ELA AVIACIÓN, S.L.
SERVICE BULLETIN Nº 17.

Inspection/action required in new type of rotor hub (P/N: 07-143)

Date of issue: 5th September 2013.

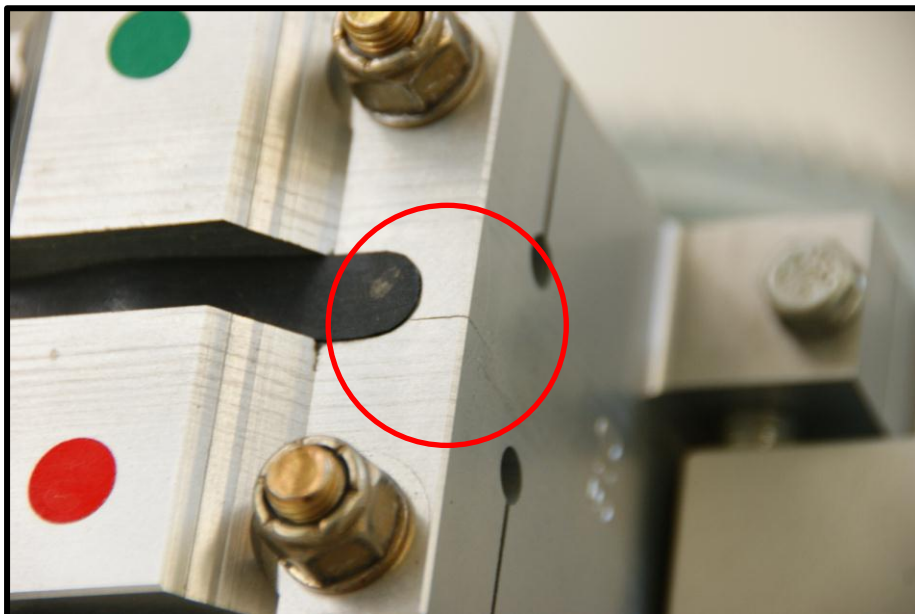
A few customers have reported small cracks in this part. See pictures.

After investigation of those cracks we have determined that the tightening of the four bolts that hold the hub bar to the block (rotor hub) can cause the appearance of those cracks.

Rotor hubs with apparition of cracks are not airworthy and should be replaced.

1) A visual inspection is required before the next flight to confirm the absence of cracks.
In case of cracks contact the factory for replacing the rotor hub.
